Reference: 7317434 Manitoba Ltd. - Crystal Spring Colony Wastewater Lagoon – File No. 6193.00

Subject: Technical Advisory Committee Response

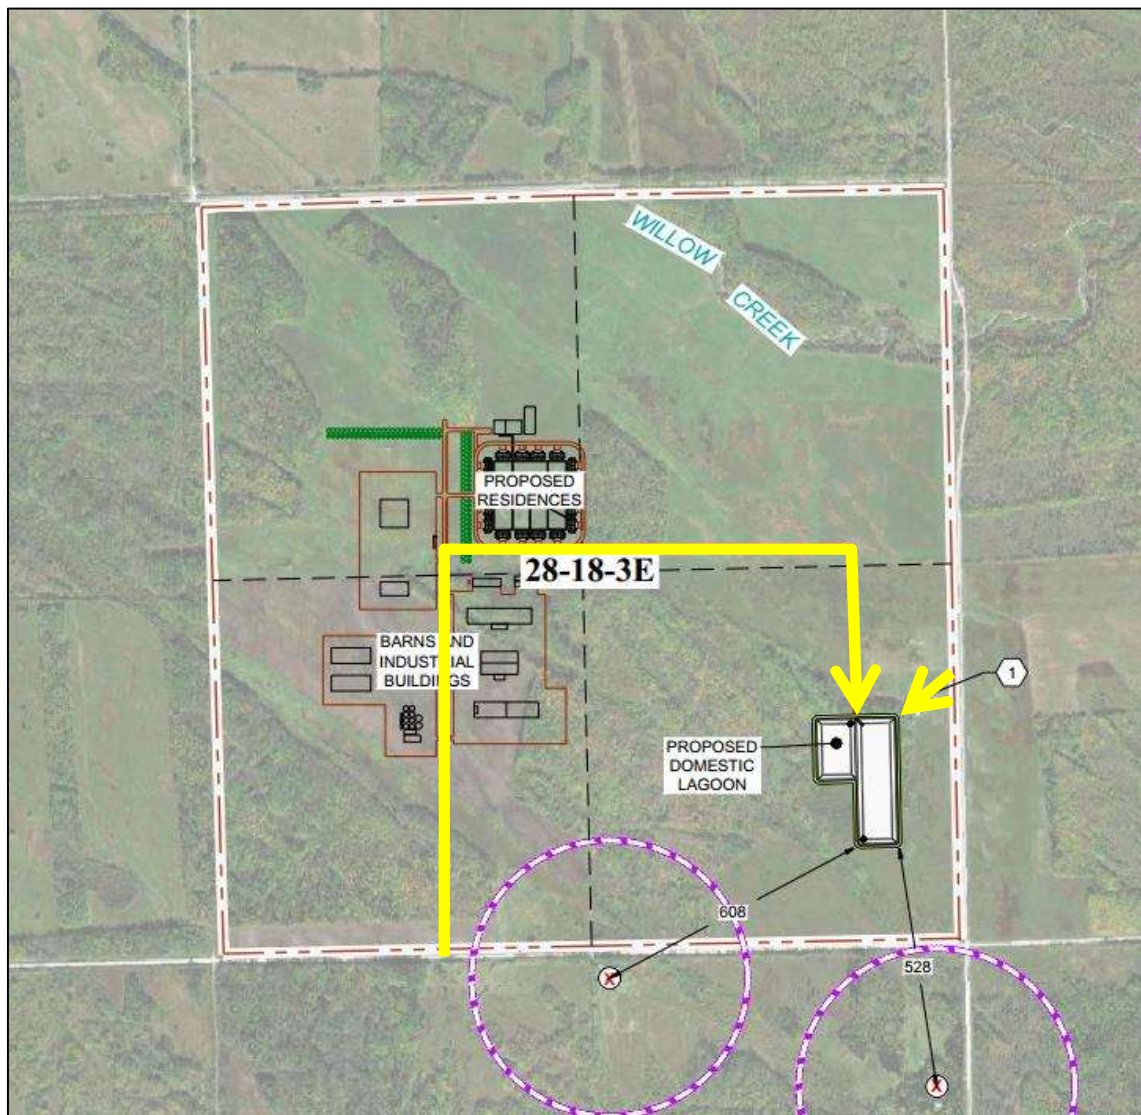
Q77: Under summer drought conditions (e.g., 2021), Willow Creek may have virtually no flow; effluent dilution as suggested in the proposal would have an adverse impact: provide a discussion on the effluent dilution and associated effect, if any, on Willow Creek and Lake Winnipeg.

A77: Drought conditions are optimal conditions for lagoon discharge. This will allow for increased uptake of nutrients and polishing of effluent by vegetation, especially in the 1.1 km ditch prior to discharging to Willow Creek. No adverse effects are expected due to discharging during drought conditions on either Willow Creek or Lake Winnipeg.
